Town Council Meeting

October 23, 2023 at 6:00 PM

- 3.** Consideration and Approval: **Final Subdivision Plans - Hillside Groves**
- 4.** Consideration and Approval: (First Reading) **Ordinance 2023-012 - Land Development Code (LDC) Omnibus**

TO: Howey-in-the-Hills Town Council
CC: J. Brock, Town Clerk
FROM: Thomas Harowski, AICP, Planning Consultant
SUBJECT: Hillside Groves Phase 1 Final Subdivision Plan
DATE: October 3, 2023

L201

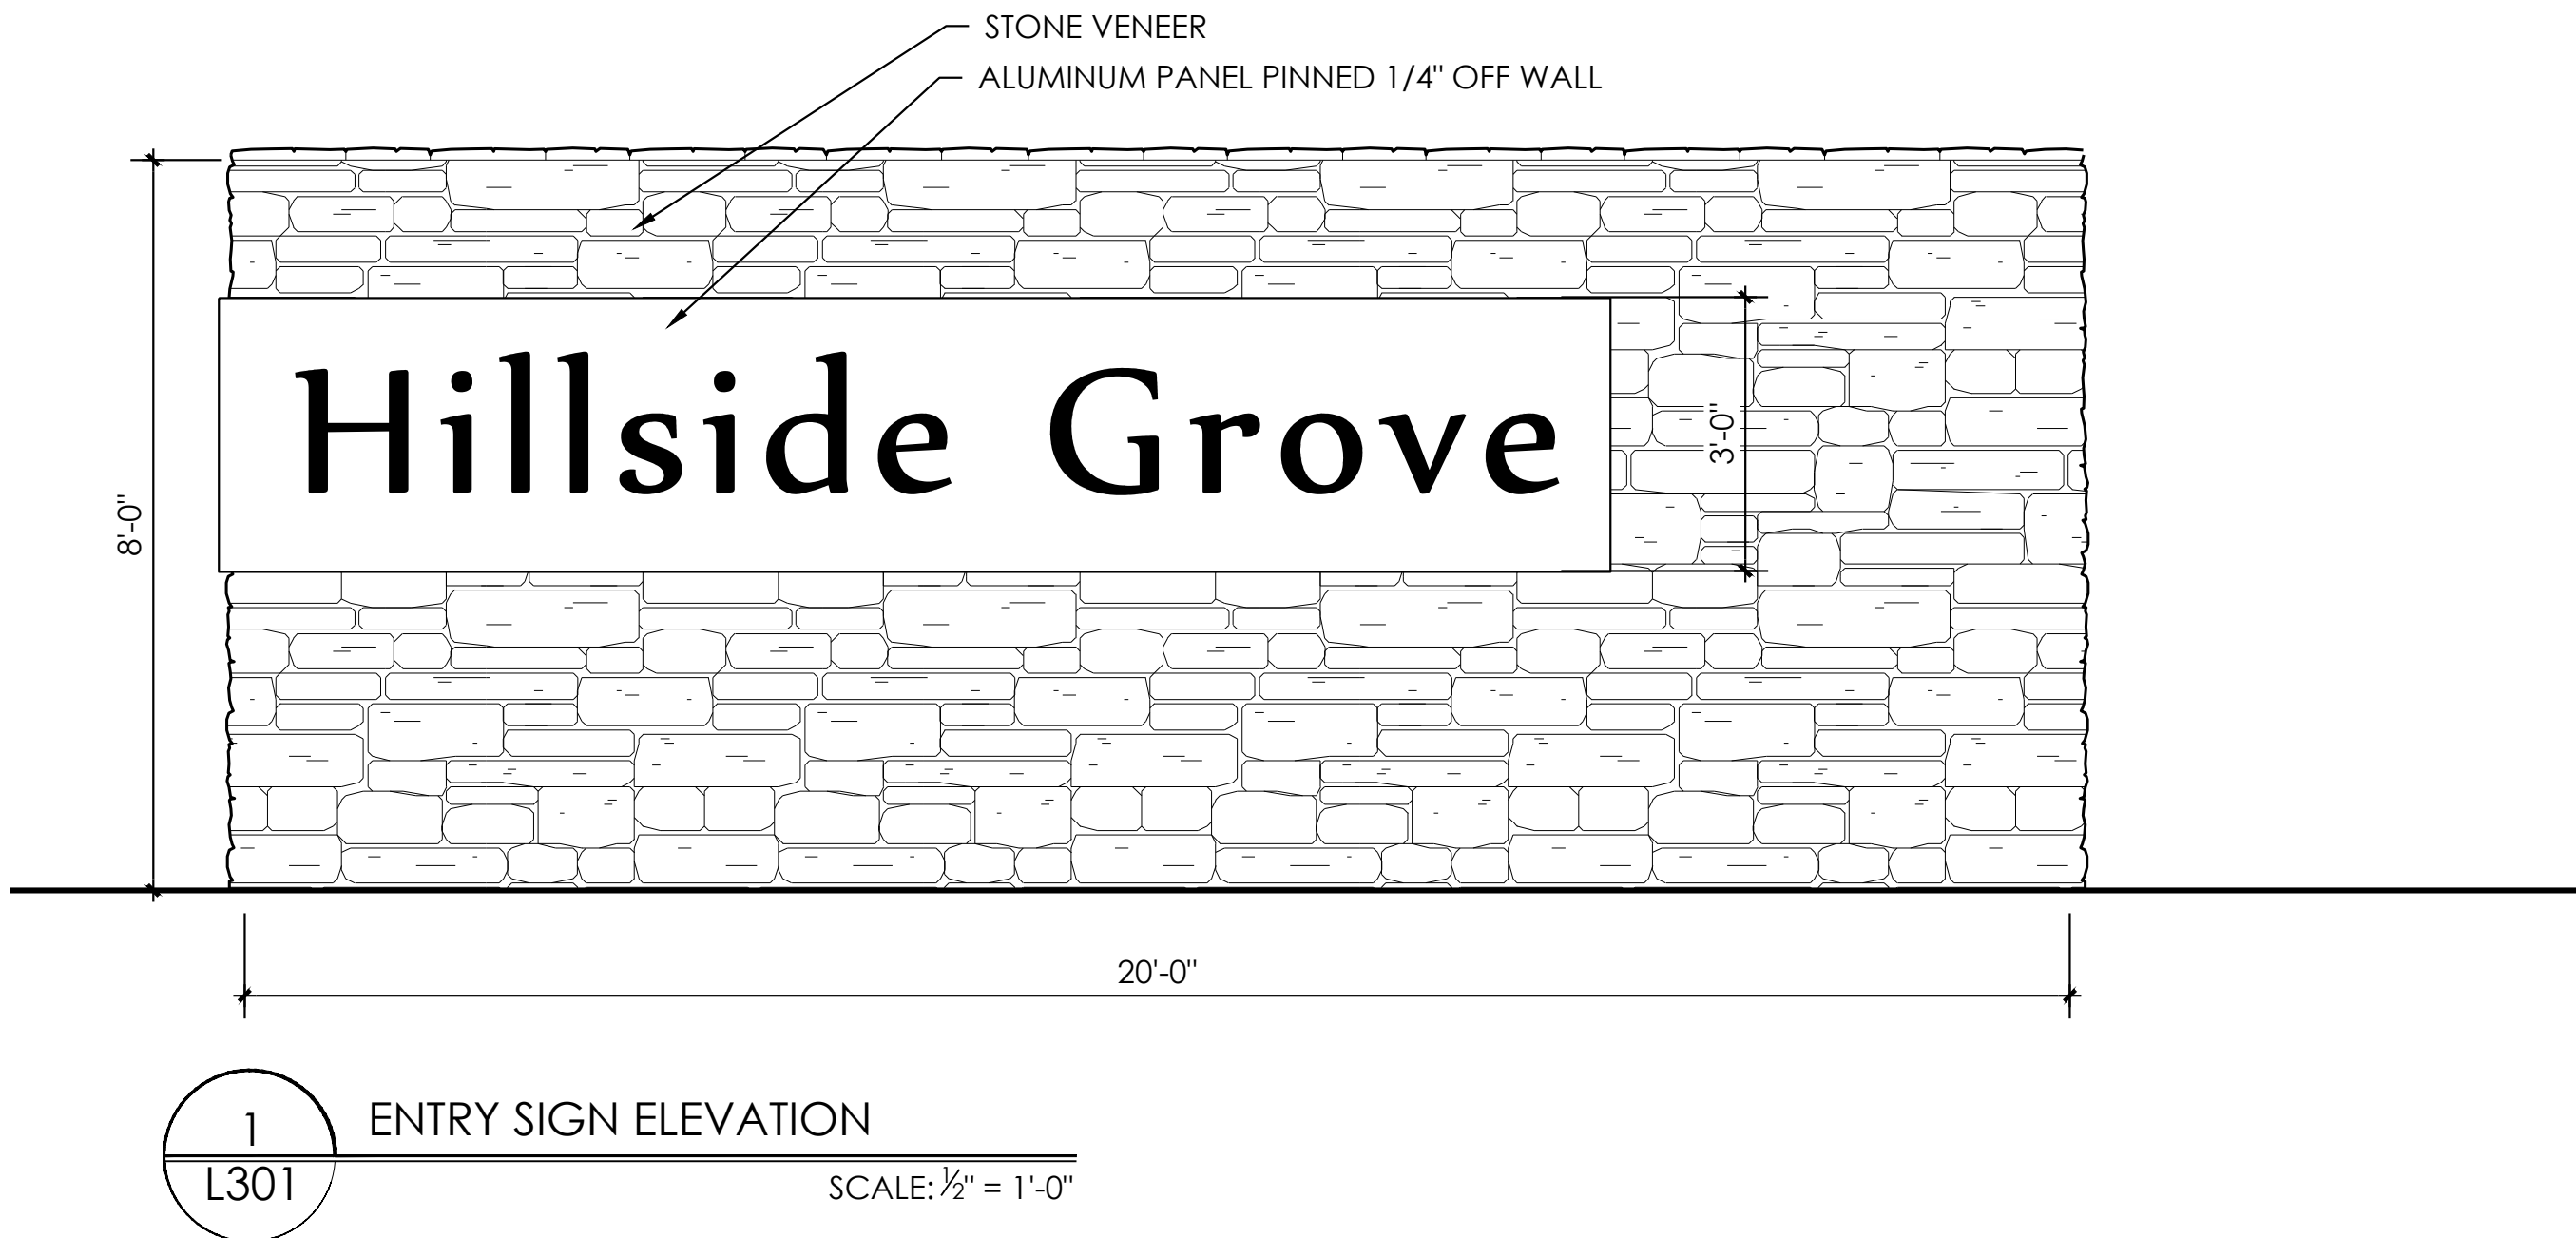
1. The response identified a note on Sheet 201 of the landscape plans stating that designs for the screening wall and entrance feature for the Number 2 Road access will be submitted with the Phase 2 plans. I could not locate the note.
